APPLICATION NO.	FILING DATE	FIRST NAMED INVENTOR	ATTORNEY DOCKET NO.	CONFIRMATION NO.
10/800,867	03/16/2004	Masayuki Takenaka	118363	1563

Office Action Summary	Application No. 10/800,867	Applicant(s) TAKENAKA ET AL.	
	Examiner Nguyen N. Hanh	Art Unit 2834

- 1) ☒ Responsive to communication(s) filed on Amendments filed on 6/22/06.
- 2a) ☒ This action is **FINAL**. 2b) ☐ This action is non-final.
- 3) ☐ Since this application is in condition for allowance except for formal matters, prosecution as to the merits is closed in accordance with the practice under *Ex parte Quayle*, 1935 C.D. 11, 453 O.G. 213.

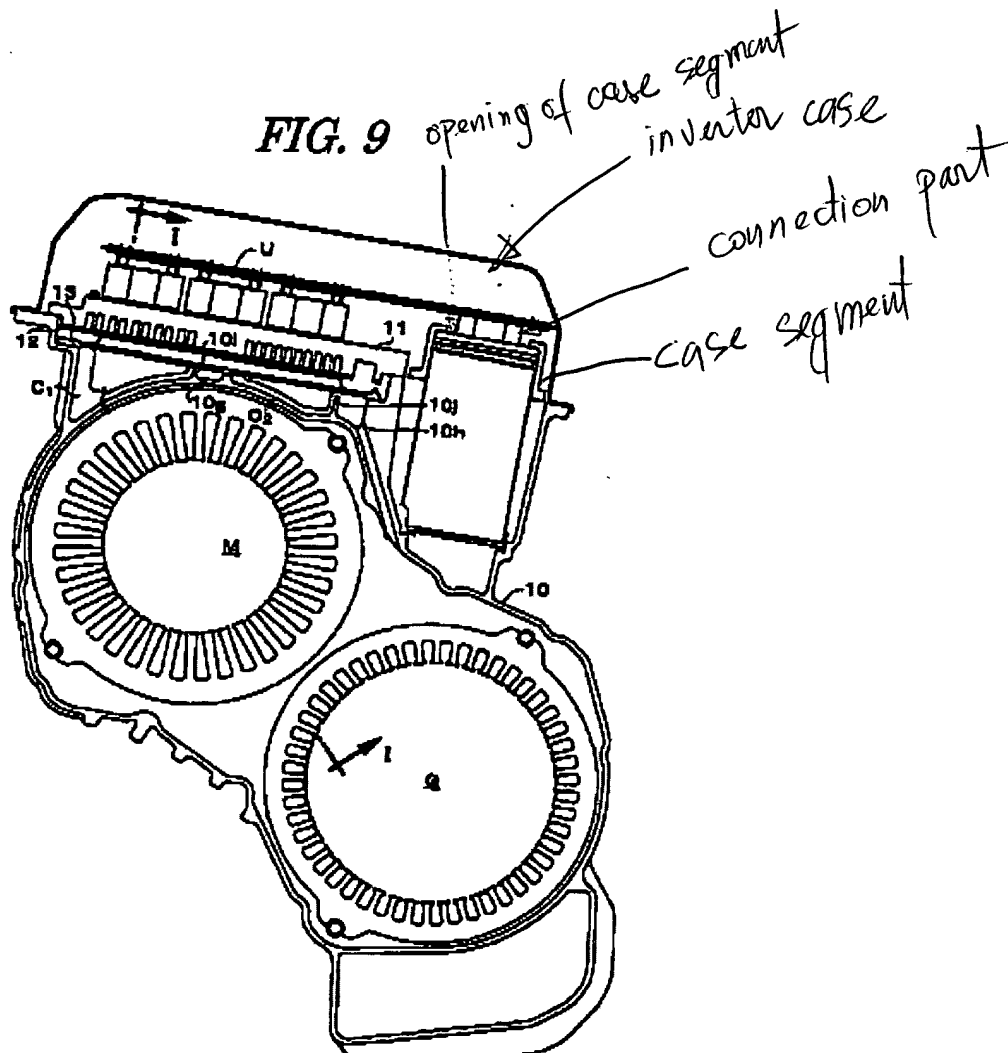
Regarding claims 15, 19 and 20, Hara et al. disclose a drive system wherein the electric power devices are connected to the respective inverters with connection parts (please see markups below) which extend out from the corresponding case segments.

Regarding claims 21 and 16, Hara et al. disclose a drive system wherein each of the connection parts has a terminal which extends through the corresponding case segment and which projects into the inverter case (Fig. 9).

Regarding claims 17 and 22, Hara et al. disclose a drive system wherein each of the terminals is positioned near an opening of the corresponding case segment.
